PLANNING, ZONING, & BUILDING DEPARTMENT
PZ&B Staff Combination Memorandum: Town Council and Architectural Commission

SUBJECT: ARC-24-038 (ZON-24-045) 207 PENDLETON AVE (COMBO)

MEETING: MARCH 27, 2024
APRIL 10, 2024

④ **CUBIC CONTENT- PROPOSED**

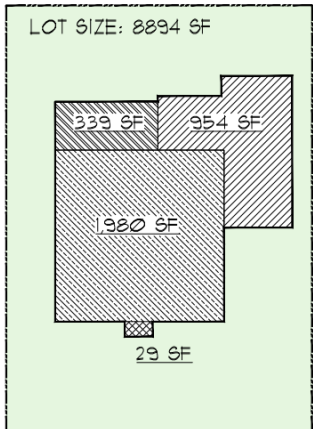
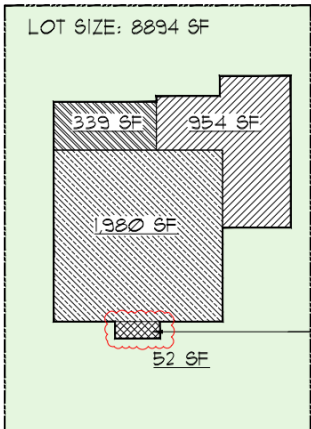
The structure is an existing nonconforming structure as it pertains to lot coverage with a 37.1% coverage where 30% is permitted. The cubic content ratio existing is also non-conforming, with 4.51 existing and 4.31 maximum permitted. The expansion of the covered entry however exacerbates these nonconformities by increasing lot coverage to 37.4% and CCR to 4.52. Therefore, two requests are being pursued by the applicant for review by Town Council for the enlargement of the front entry.

VARIANCE 2 Section 134-893(b)(13)(a)(1)	Cubic Content Ratio: 4.31	Existing: 4.51 Proposed: 4.52	0.01
--	------------------------------	----------------------------------	------

② **LOT COVERAGE- PROPOSED**

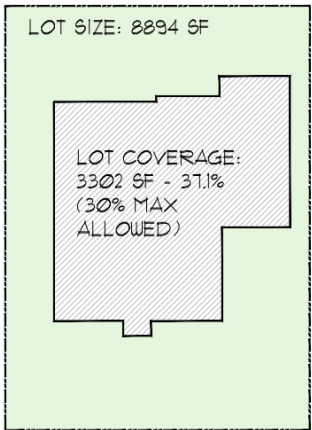
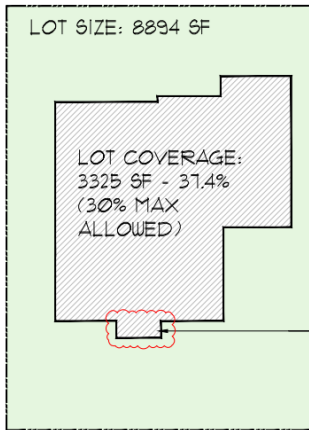
Code Section	Permitted	Existing & Proposed	Variance
VARIANCE 1 Section 134-893(b)(11)(b)	Lot Coverage: 30% (2668 SF)	Existing: 37.1% (3302 SF) Proposed: 37.4% (3325 SF)	0.3% (657 SF)
